**05-008/14 - MULTI-MODEL (6 SPEED SKYACTIV M/T) - HARD
TO SHIFT INTO 3RD, 4TH, 5TH AND/OR 6TH GEAR**

Service Bulletin

Subject: HARD TO SHIFT INTO 3RD, 4TH, 5TH AND/OR 6TH GEAR	Bulletin No: 05-008/14
	Last Issued: 11/26/2014

- This bulletin supersedes the previous bulletins 05-008/14 issued on 07/14/14. The APPLICABLE MODELS, DESCRIPTION, REPAIR PROCEDURE, and WARRANTY INFORMATION have been revised.
- Changes are noted below beside the change bar in Red.

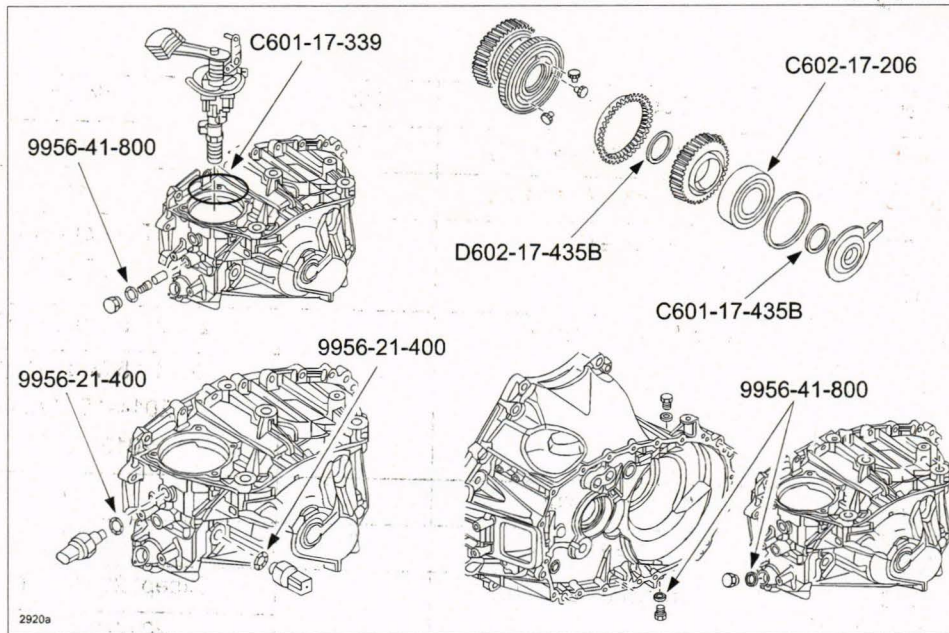
This is caused by a failure of the related clutch hub(s). To correct the problem of hard shifting, the shape of the 3-4 and 5-6 clutch hub has been changed. A surface treatment has now been added to the 3-4 clutch hub to prevent 3rd gear from jumping out.

1. Verify customer concern.
2. Remove the transaxle. Refer to MS3 online instructions or the Workshop Manual section 05-15.
3. Replace the 3-4 and 5-6 clutch hub with a modified one and the 3rd gear with a new one (listed in the Parts Information). Refer to the C66M-R 6-speed SKYACTIV Manual Transaxle Workshop Manual.

- Bearing Puller part number 4907-10-520-L is used for this repair.
 - If 3rd gear is jumping out, replace the 3rd gear with a new one.
4. Install the transaxle.
 5. Verify repair.
